Property Information	Bancroft Pointe Subdivision		
Address	226 Bancroft Chapel Rd. Kingsport, TN		
Tax Map, Group, Parcel	Tax Map 090, Parcel 059.00		
Civil District	10 th Civil District		
Overlay District	Floodplain		
Placetype Designation	Suburban Living		
Acres	+/- 10.06		
Major or Minor / #lots	Major – 43 lots	Concept Plan	
Two-lot sub		Prelim/Final	Preliminary
Owner/ Applicant Information		Surveyor Information	
Name:		Name:	
Address:		Address:	
City:		City:	
State: Zip Code:		State: Zip Code:	
Phone:		Phone:	
Planning Department Recommendation			
<p>The Kingsport Planning Division recommends contingent Preliminary Approval for the following reasons:</p> <ul style="list-style-type: none"> • The plat meets the City’s minimum regulations for subdivisions. • Construction Plans are still being reviewed and updated. <p>Staff Field Notes and General Comments: The applicant is requesting preliminary plat approval for the Bancroft Pointe subdivision, which consists of 43 lots located off Bancroft Chapel Road.</p> <p>The development is proposing a residential street cross-section that conforms to the minimum design standards found in the subdivision regulations. The maximum distance the

Proposed Residential Street Cross-Section

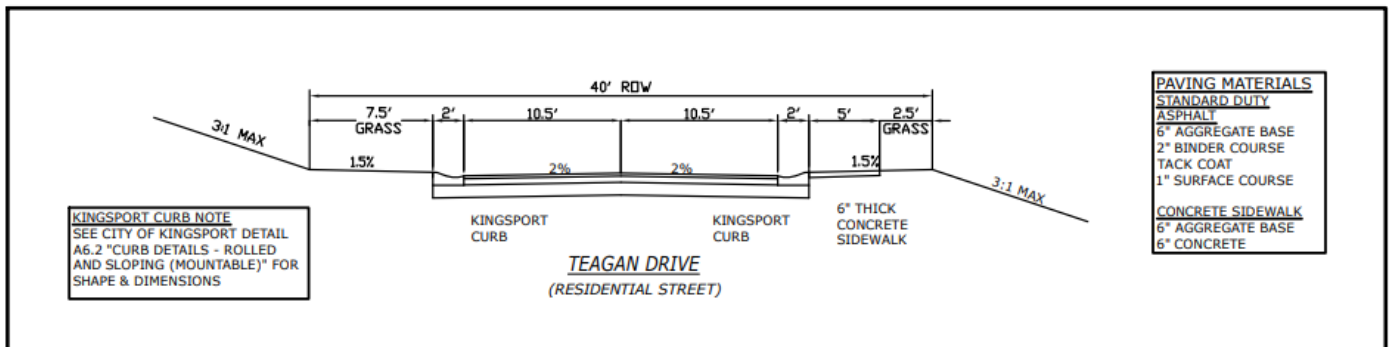
We are requesting the street length be allowed to be 1,374' from the beginning of the roadway to the center of the proposed cul-de-sac versus the maximum length of 1,250'. This 124' of additional roadway length will allow for adequate space for Pond 2 at the eastern portion of the site.

Staff recommends granting preliminary plat approval for the Bancroft Pointe Subdivision and approving the variance for an additional 124' for Teagan Drive, contingent upon the construction plans being approved.
